Access Compliance Report

Public Rights-of-Way

Intersection ID: 16149	Main Street: SARAH_DR	Cross Street: W_CAMA_ST	Location: SE
ADA ID: 7C1D4A34E637	Ramp Type: PerpDiag	Initial Pass/Fail: Fail	Overall Compliance: No
		Severity Score: 8.75

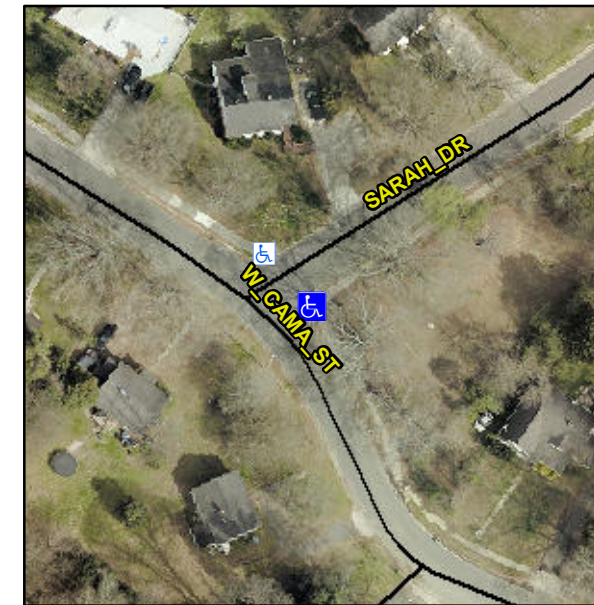
Not Found, R304.5.1

Compliance	Description	Data	Compliance	Description	Data
N/A	Ramp Length (in)	84.0	Yes	Ramp Slope (%)	5.2
No	Ramp Width (in)	38.0	Yes	Ramp XSlope (%)	0.7
N/A	Flare Type LT	N/A	N/A	Flare Type RT	N/A
N/A	Flare Slope LT (%)	N/A	N/A	Flare Slope RT (%)	N/A
N/A	Flare Traversable LT?	N/A	N/A	Flare Traversable RT?	N/A
N/A	Landing Length (in)	N/A	N/A	DWS Provided?	N/A
N/A	Landing Width (in)	N/A	N/A	DWS Contrast?	N/A
N/A	Landing Slope (%)	N/A	N/A	DWS Length (in)	N/A
N/A	Landing X Slope (%)	N/A	N/A	DWS Full Width?	N/A
N/A	Landing Curb? (Y/N)	N/A	N/A	DWS Offset (in)	N/A
N/A	Shared Landing?	N/A			
N/A	Gutter Ponding?	N/A	N/A	Gutter Slope (%)	N/A
N/A	Gutter Lip Ht (in)	N/A	N/A	Gutter X Slope (%)	N/A
N/A	Painted X Walk1?	No	N/A	Painted X Walk2?	No
	X Walk 1 Direction	To NW		X Walk 2 Direction	To SW
N/A	X Walk 1 Width (in)	N/A	N/A	X Walk 2 Width (in)	N/A
	X Walk 1 Slope (%)	0.9		X Walk 2 Slope (%)	4.0
	X Walk 1 X Slope (%)	0.4		X Walk 2 X Slope (%)	1.0

Remove & Replace Curb Ramp With Two New Directional Ramps or Equivalent.
